ZRD1: Zoning Resolution Determination Form

House No(s) 112-13 Street Name Roosevelt Avenue
Borough Queens Block 1786 Lot 44 BIN 4045001 CB No. 306

Primary Zoning Resolution or Code Section(s): ZR 33-23(b), ZR 12-10 "story" definition, ZR 32-16

E: SITE PLAN & NOTES

PROPOSED MEZZANINE FLOOR PLANN
SCALE: 3/16" = 1'-0"

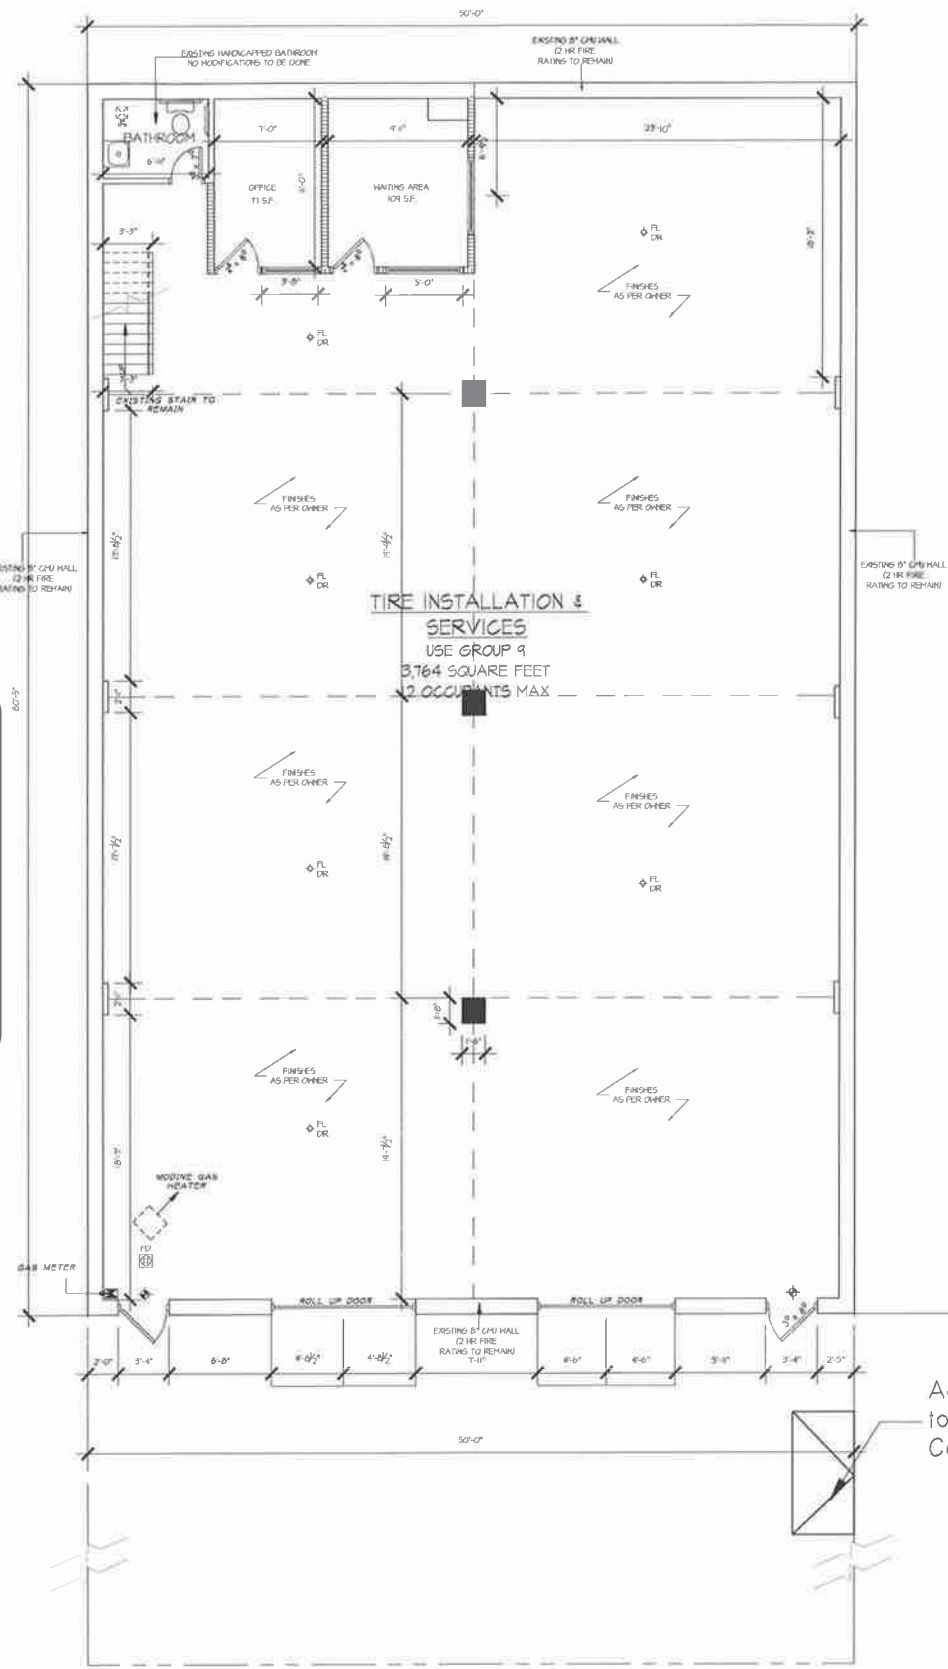
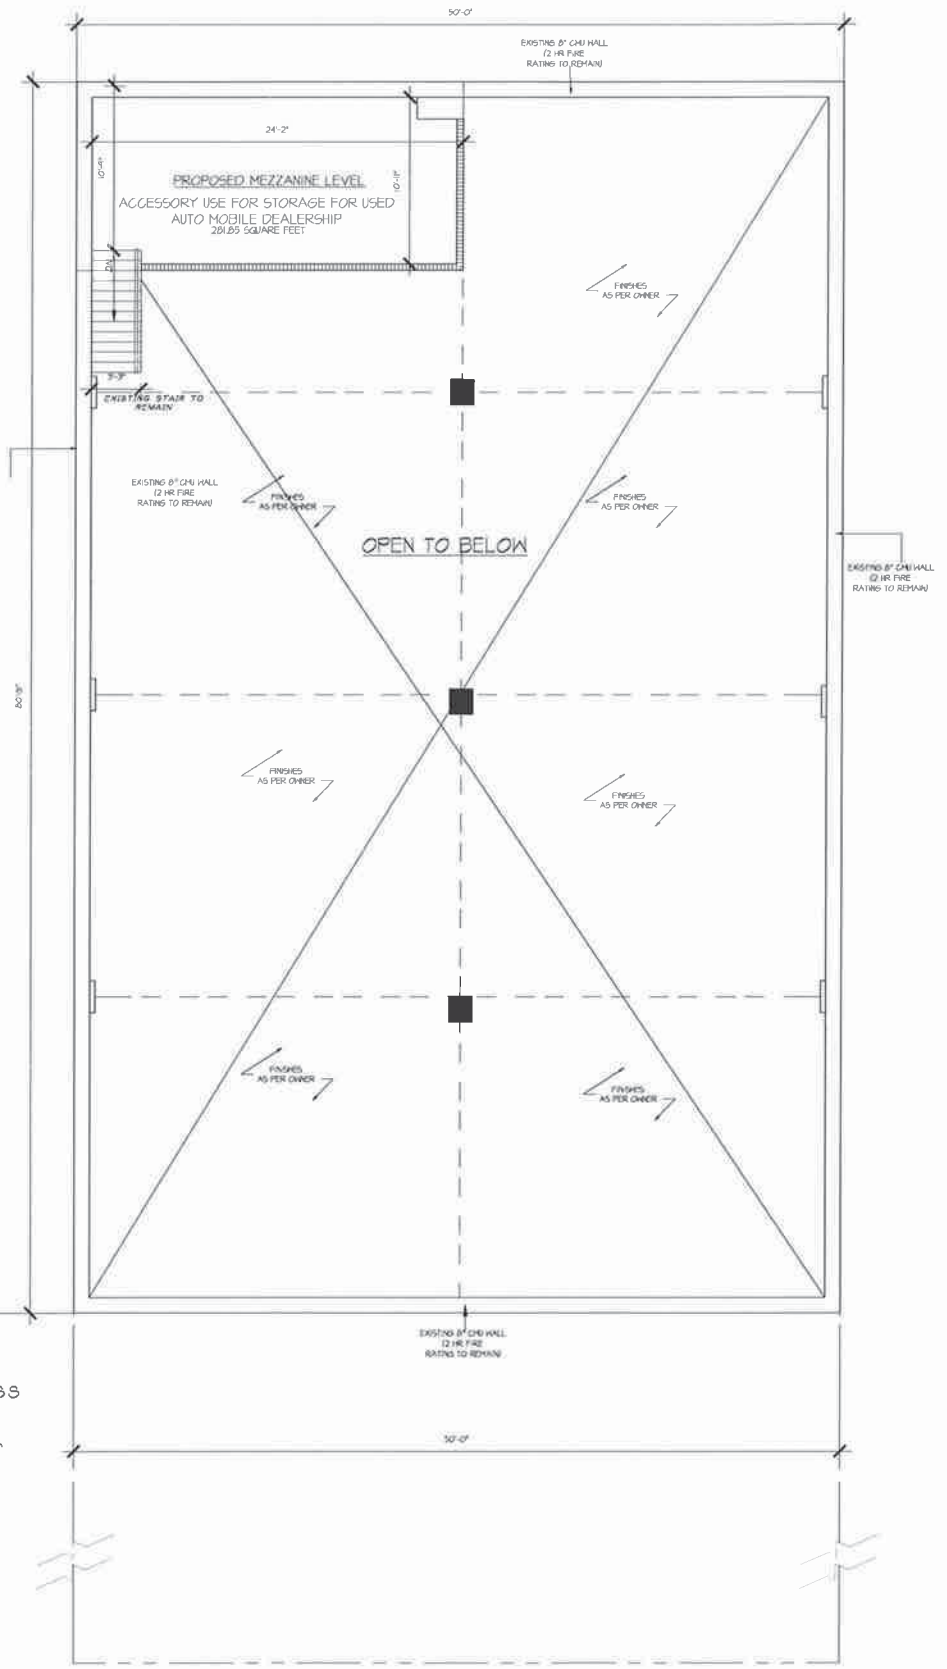
We respectfully request determination on comment raised by the plan examiner as stated
"Provided Mezzanine floor on plan is prohibited in rear yard as per ZR 33-23(b)3

This is an existing one story 15' high building, which the proposed uses are Used Auto Car Sales dealership and Tire Shop with Installation Services. The proposed mezzanine is 281 SF (24'2 x 10' 11) which is in the rear portion of the 1-story which is permitted obstruction as per 33-23(b)(3) up to 1 - story and 23' ft above the curb level. Therefore since the mezzanine is not a story it is permitted in the rear yard. (See definition of mezzanine below)

As Per 12-10 the definition of Mezzanine is An intermediate floor between the floor and ceiling of any space. When the total gross floor area of all mezzanines occurring in any story exceeds thirty-three and one-third percent of the gross floor area of that story such mezzanine shall be considered as a separate story

The request, to determine that a proposed interstitial level in the required rear yard within the subject existing building does not constitute a second "story" and thus complies as a permitted obstruction as per ZR 33-23, is hereby approved with the following conditions:

- (1) Such level counts as zoning "floor area";
- (2) Such level is within a building portion that does not exceed 23'-0" above curb level;
- (3) Such level is less than 1/3 of the gross area of the first floor below;

- (4) Such level qualifies as a "mezzanine" as per BC 505;
- (5) Because the "mezzanine" would count as zoning "floor area" (and a non-conforming use cannot be enlarged), the uses within the building must be conforming uses in this C2 district. Therefore, proposed UG 9A auto showroom and UG 7D auto service establishment must be SEPARATE establishments because the UG9A auto showroom shall not have any repair services or preparation for delivery. Once the plan has been amended to the examiner's satisfaction, a note requiring physically separate establishments shall be placed on the Schedule A and resultant C of O; and

- (6) As per ZR 32-412, all automobiles, for either service or sale, shall be located within a "completely enclosed building" (as defined by ZR 12-10). A note requiring this shall be placed on the Schedule A and resultant C of O.
